U. S. NUCLEAR REGULATORY COMMISSION  
DOCKET 70-3070  
LOUISIANA ENERGY SERVICES, L.P.  
NOTICE OF AVAILABILITY OF THE  
SAFETY EVALUATION REPORT  
FOR THE CLAIBORNE ENRICHMENT CENTER  
HOMER, LOUISIANA

# Safety Evaluation Report

## for the Claiborne Enrichment Center, Homer, Louisiana

Docket No. 70-3070

Figure 2.4 Location of oil and gas pipelines within 8 kilometers of the CEC site

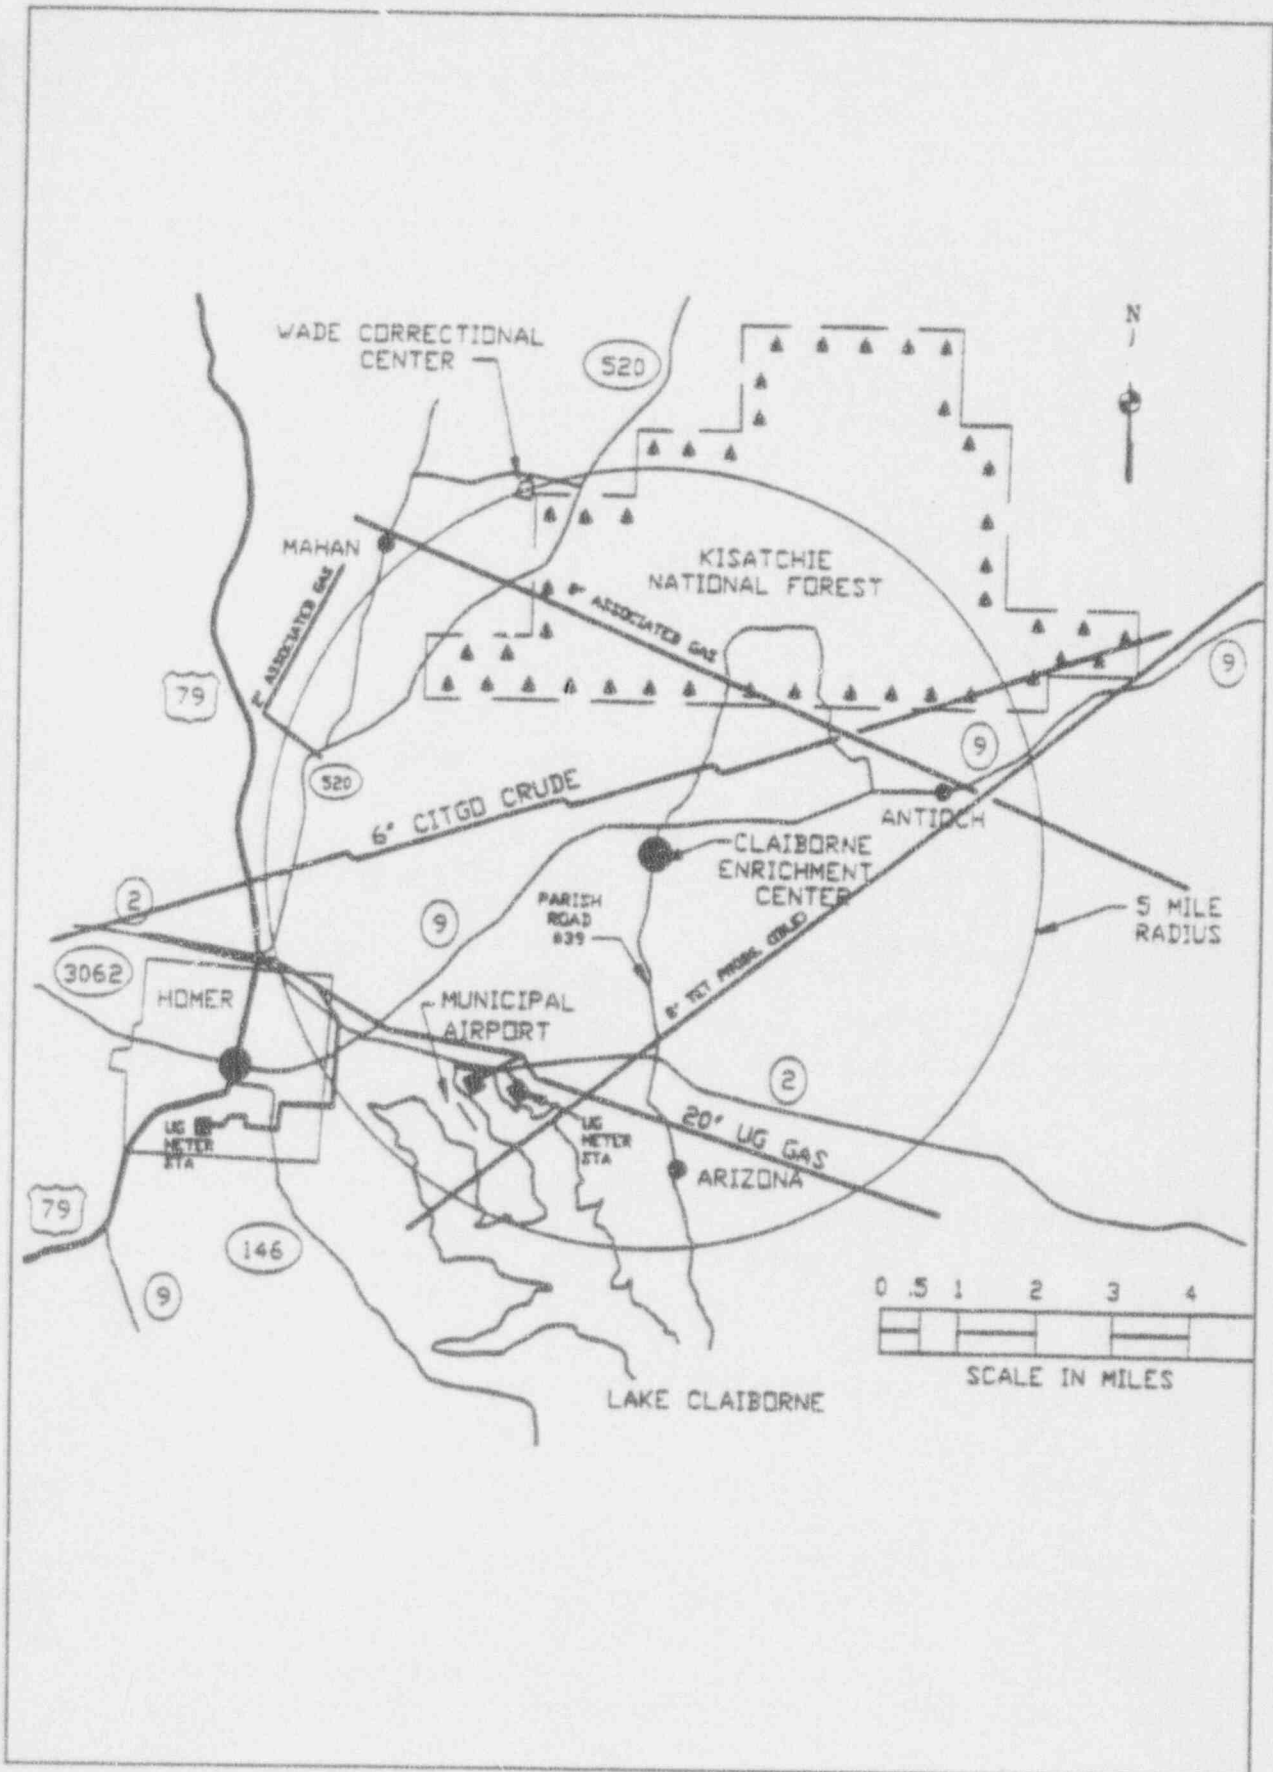
No gas or oil pipelines cross the CEC site. Five pipelines are located within 8 kilometers (5 miles) of the CEC site (approximate shortest distance to the CEC facility indicated), as shown in Figure 2.4:

The applicant has analyzed the potential hazard of operation of nearby oil and gas lines (LES, 1993a). The analysis considered the 50-cm (20-inch) United Gas line located 6 kilometers (4 miles) south of the facility and referred to prior analysis completed in relation to operation of the Susquehanna Steam Electric Station. This analysis evaluated the operation of a 105-centimeter (40-inch) pipeline located 2 kilometers (6700 feet) from the power plant. Evaluation of failure of the pipeline considered blast over-pressure, thermal radiation, and missiles and concluded that plant operation would not be affected by the pipeline failure. Because the pipeline under evaluation has lower capacity and lower operating pressure, the applicant concluded that pipeline failure would not affect CEC operation.

The NRC staff reviewed the applicant's analysis of gas pipeline operation and concludes that operation of such lines at the present distances from the CEC does not pose a risk to safe operation of the facility.

Figure 4.2 Plant unit process flow schematic

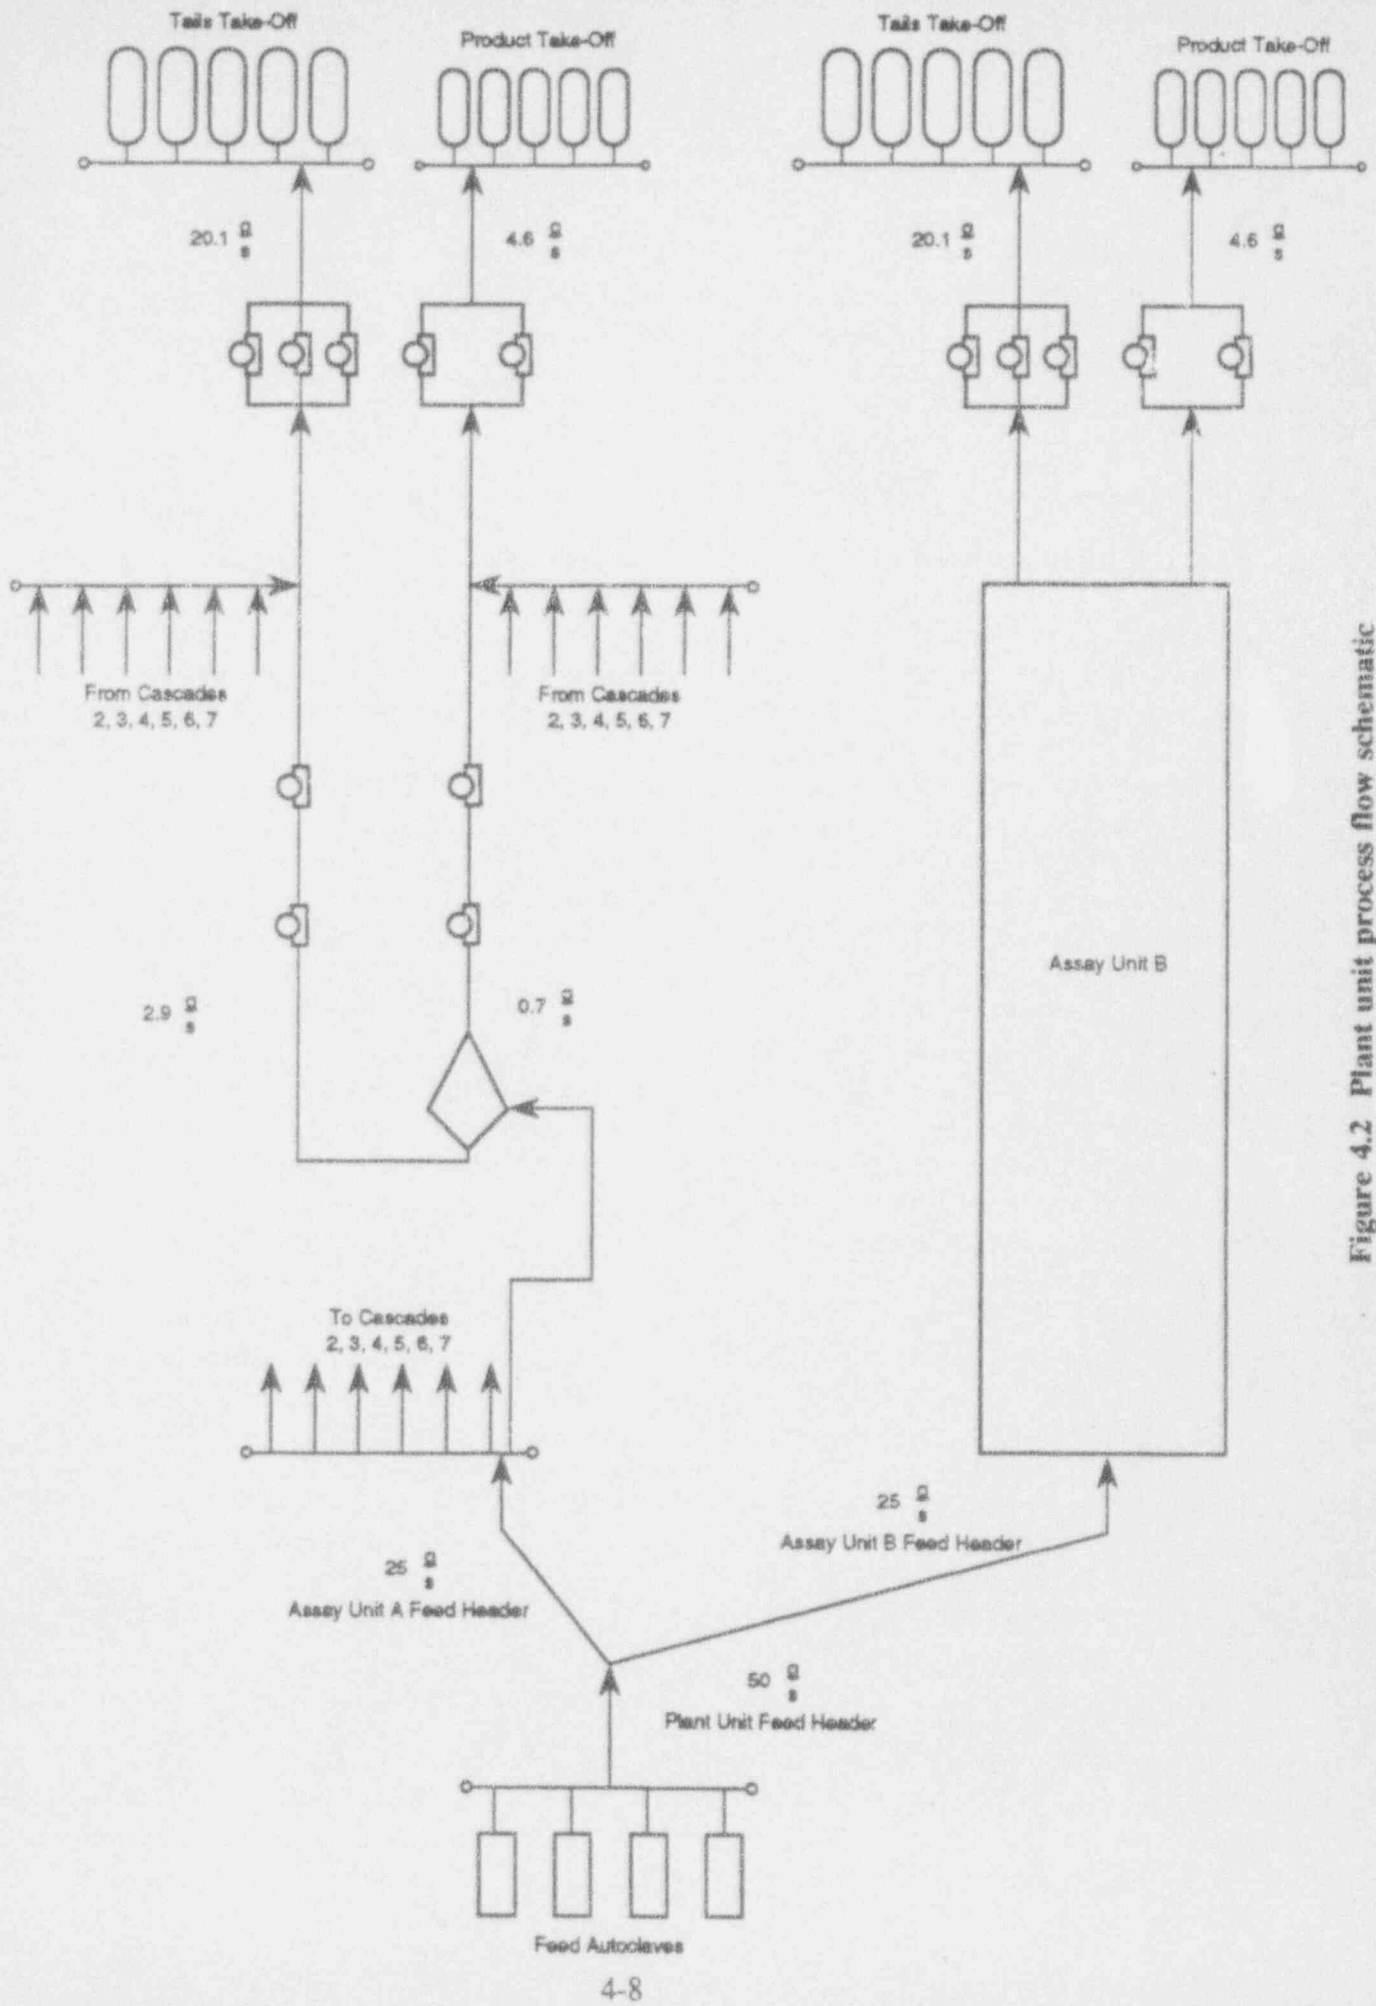
UF<sub>6</sub> moving through the CEC systems were also considered as potential hazard sources for continuous releases. A schematic of the flow configuration for one of the three plant units is presented in Figure 4.2. The flow configurations for the other two plant units are identical to the system represented in this figure. The maximum flow rate in any one pipe is approximately 50 grams per second, with product flows from individual cascades as low as 0.7 grams per second. The hazard audit did not identify quantities of hazardous materials other than UF<sub>6</sub> which could provide a basis for identifying a protective system as important to safety.

Figure 4.3 Separations Building leakpath flow schematic

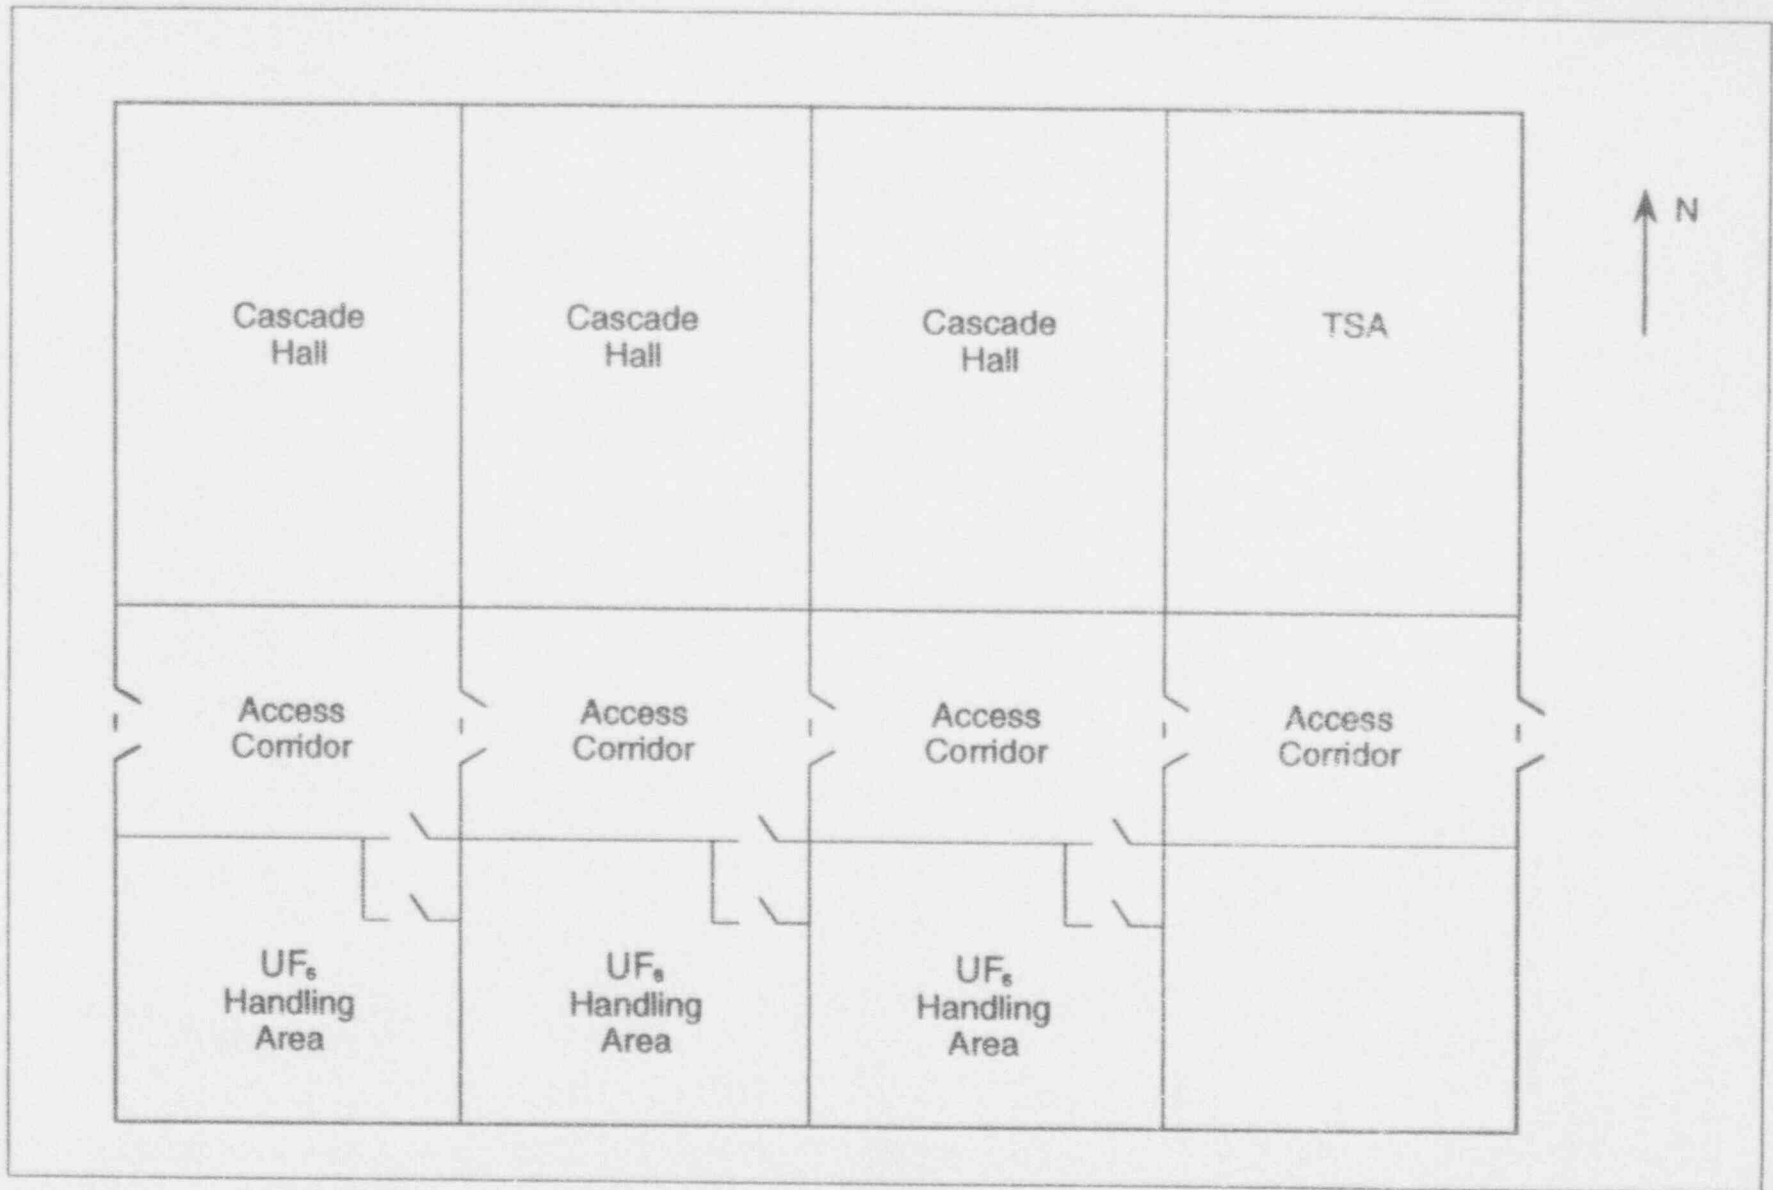
UF<sub>6</sub> releases inside the building are diluted before their release to the atmosphere. Evaluation of the degree of mixing depends in a complex manner on release dynamics and building air flow patterns. To provide a conservative analysis, the release scenarios considered the function of the building ventilation system. In the first scenario, the ventilation system remains functional, mixing in the building air is not considered, and the material is released directly to the stack without dilution in the building air. In the second scenario, the building ventilation system is shut down in contaminated areas, and the released material is dispersed into the accident compartment. In the absence of forced ventilation, normal wind flow outside the building develops a draft through the building; the result is a leakpath, or continuous release, represented as occurring at ground level. The features of the Separations Building which are relevant to this release estimate are represented in Figure 4.3. Wind flowing around the building induces a pressure drop along the path of the access corridor. Flow through this leakpath is limited by the resistance to flow through clearances around each of the doors along the access corridor. The magnitude of this resistance is estimated by using standard correlations (Blevins, 1984). Using wind speeds occurring less than 5 percent of the time (approximately 5 m/s), the NRC staff developed an estimate of leakage flow of  $0.039 \text{ m}^3/\text{s}$  (80 cfm) along the access corridor. Two doors in series separate each UF<sub>6</sub> Handling Area from the access corridor. Using the pressure distribution estimated for the

access corridor and the referenced resistance coefficients, the NRC staff estimated a leakage flow from a UF<sub>6</sub> Handling Area of 0.014 m<sup>3</sup>/s (30 cfm). As an additional conservatism, the analysis did not consider the reduction in contaminant concentration which would occur in the mixing of the UF<sub>6</sub> Handling Area leakage flow and the corridor leakage flow. In light of these considerations, Gaussian modeling is used for atmospheric dispersion modeling. The following paragraphs describe the dispersion modeling for the continuous and instantaneous release modes.

Figure 8.2 Claiborne Enrichment Center radiological access zones (LES, 1993a)

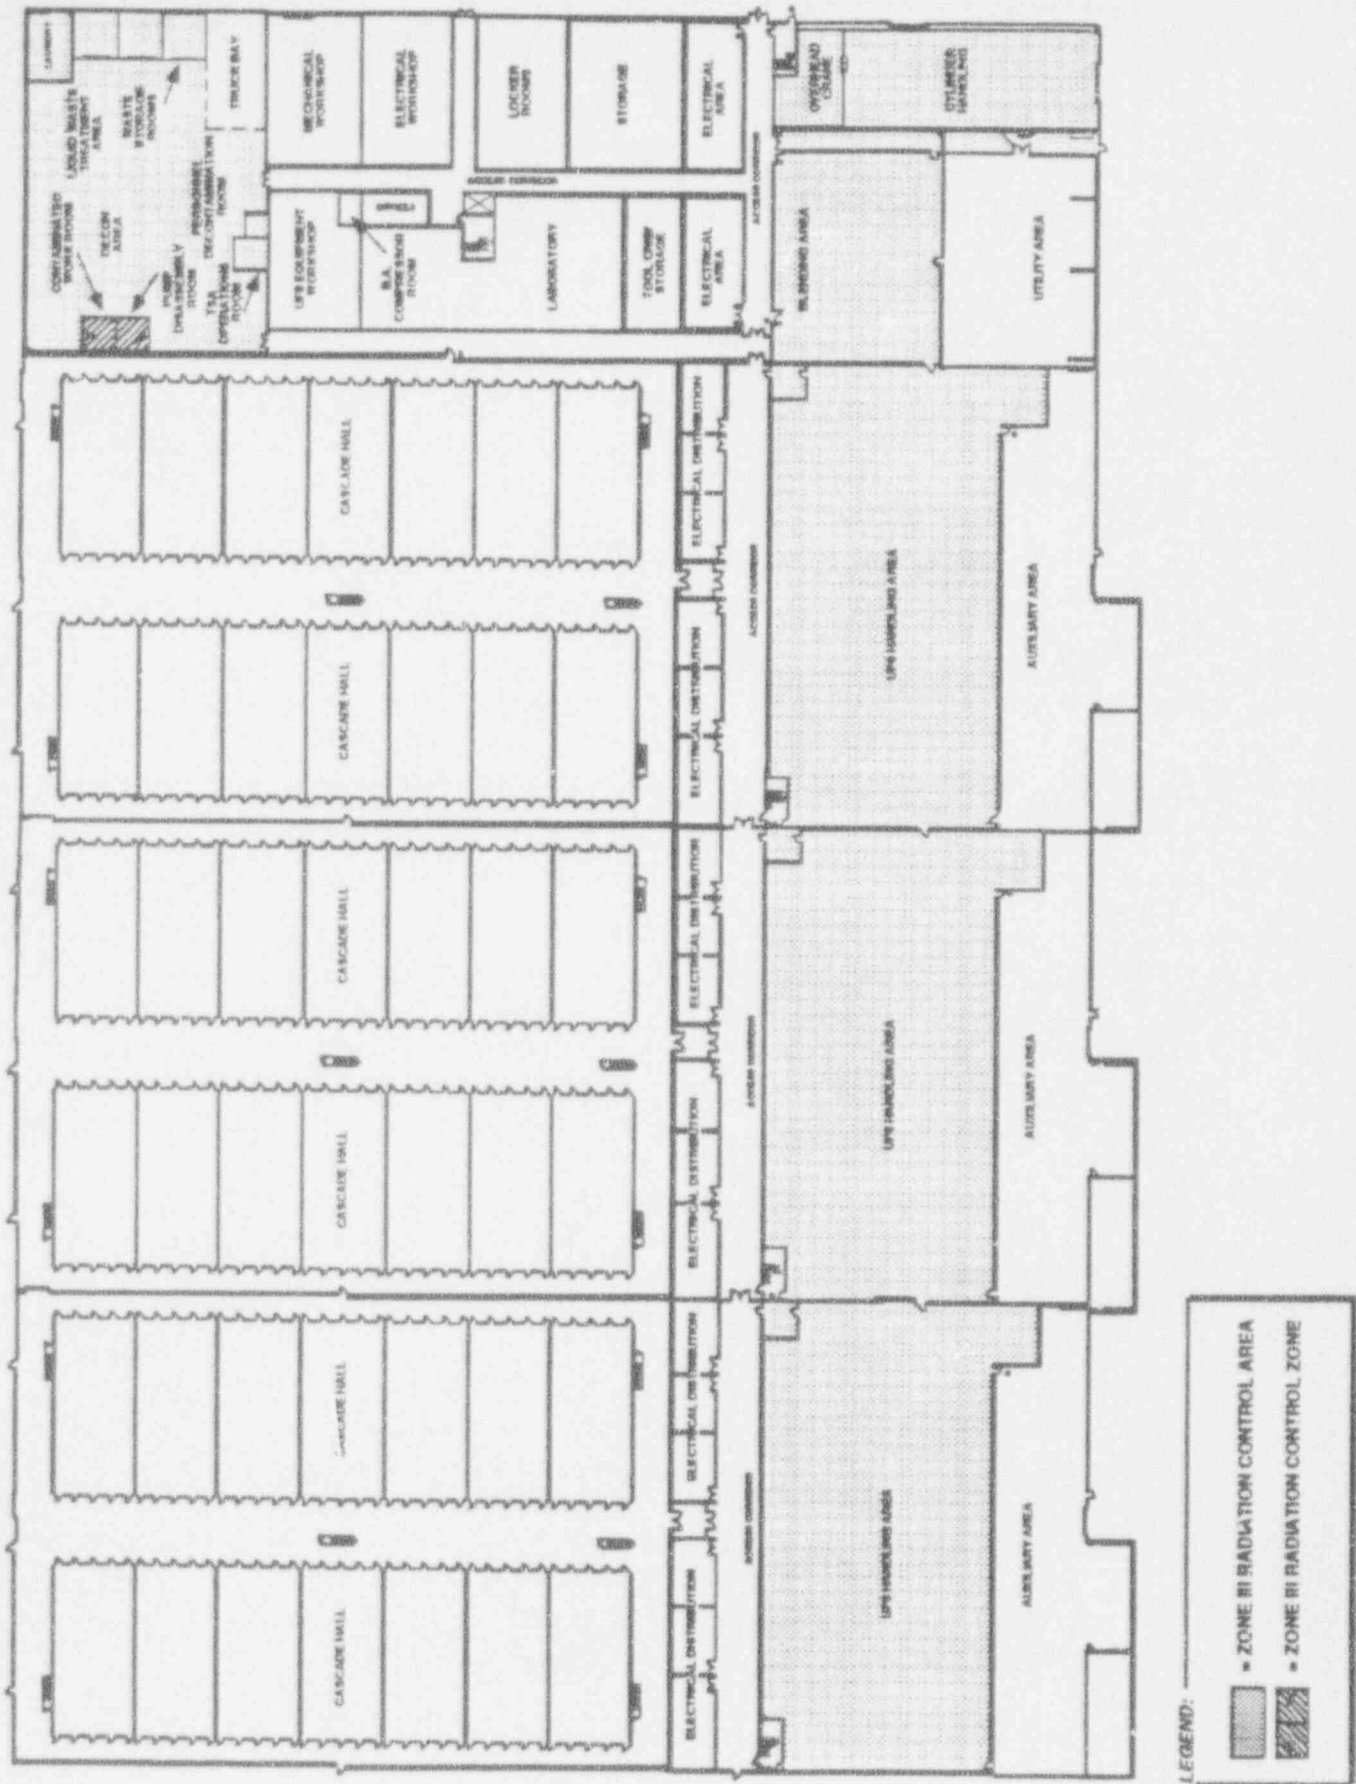
LES proposes to define radiation areas (RCA/RCZ) for protection of workers from radiation and from the chemical toxicity of uranium (see proposed CEC radiological access zones shown in Figure 8.2) as follows (LES, 1993e):

In combination, the NRC staff believes the thresholds specified in these definitions for an RCA and an RCZ will adequately identify areas where access control for the purpose of radiation protection is needed. Because of the nature of the operations to be conducted at the CEC, the first and second thresholds would not be reached except under highly unusual circumstances. The third and fourth thresholds would normally determine the RCAs and RCZs.
